**GOVERNMENT OF THE DISTRICT OF COLUMBIA
DEPARTMENT OF TRANSPORTATION**

MEMORANDUM

SUBJECT: ZC Case No. 13-12 – 1333 M Street SE

Figure 3 Walking Route to Potomac Avenue Metro Station Under Current Conditions (0.7 Miles)

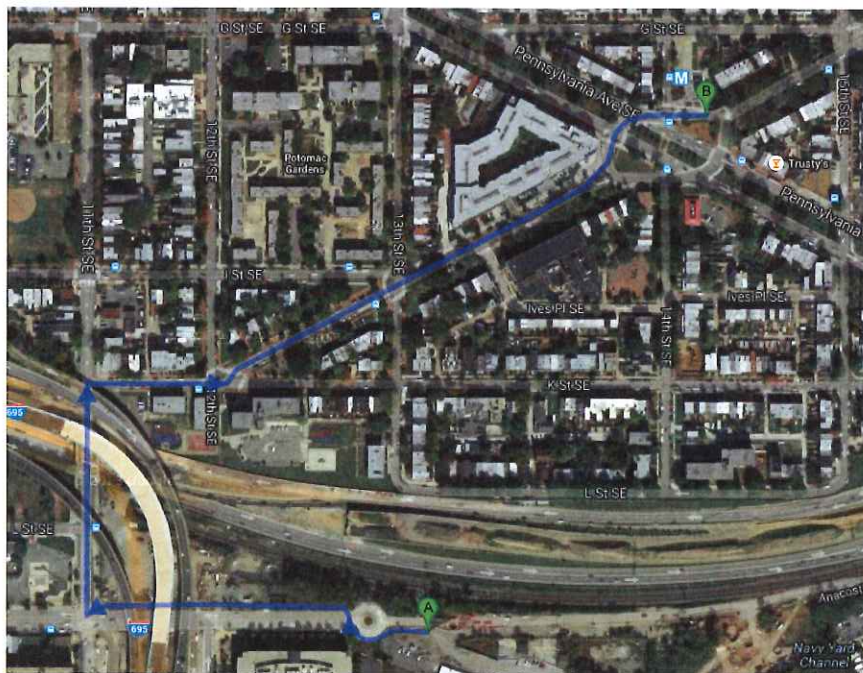
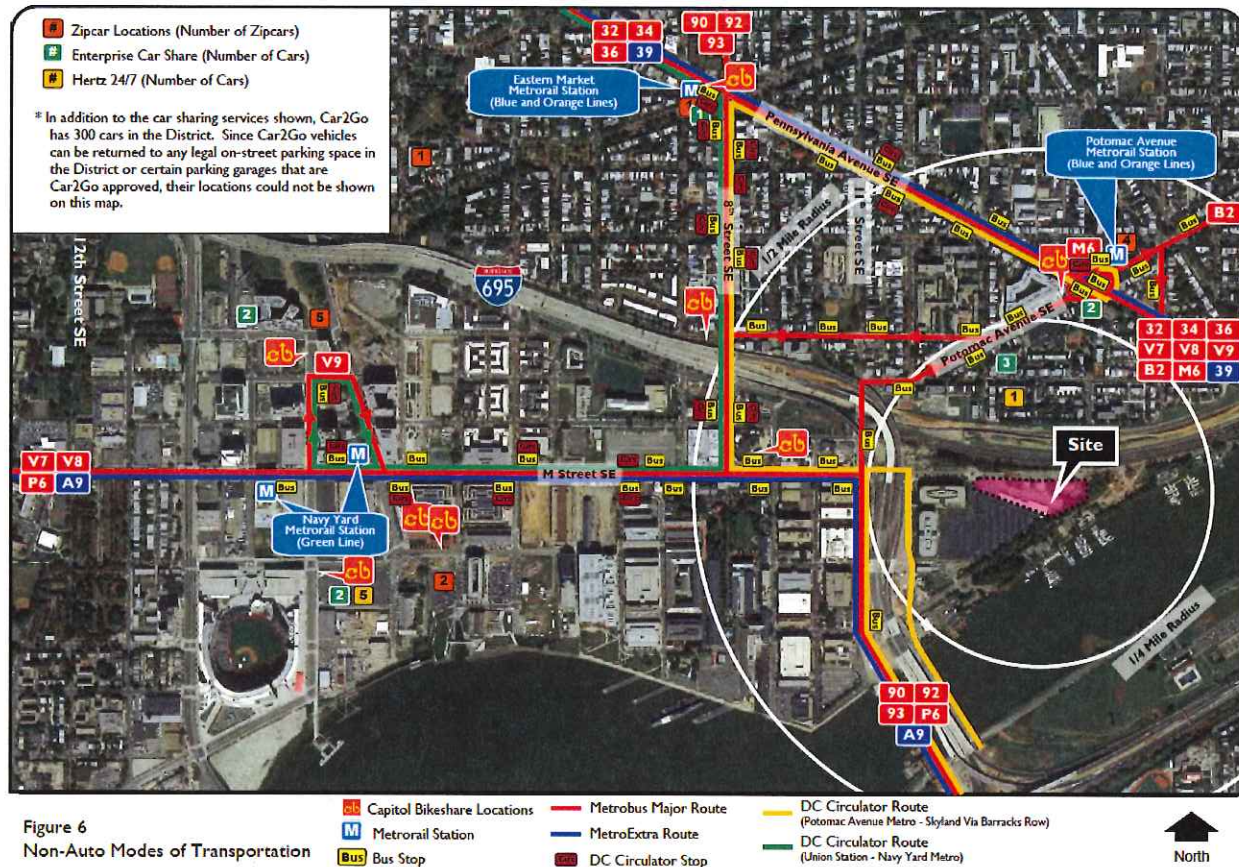
While the Potomac Avenue Metro Station is only 0.3 miles away from the subject site as the crow flies, the walking distance around the infrastructure barriers is .7 miles, or approximately a 14 minute walk. Additionally, the Navy Yard-Ballpark Metro Station is 0.9 miles to the east or an approximately 18 minute walk. Under current conditions, both Metro stations are outside of the typical ½ walkshed of heavy rail stations. Additionally, walking to either Metro station would require walking through the 11th Street bridges project area.

Easily accessible bus stops within ¼ mile of the site are also limited under current conditions. Only the V7/V9 line has stops that are accessible within ¼ mile of the site, but even then the walking distance is greater than ¼ mile due to the CSX/Southeast-Southwest Freeway barrier. Bus service is more plentiful within ½ mile of the site; however this is beyond the typical walkshed of buses.
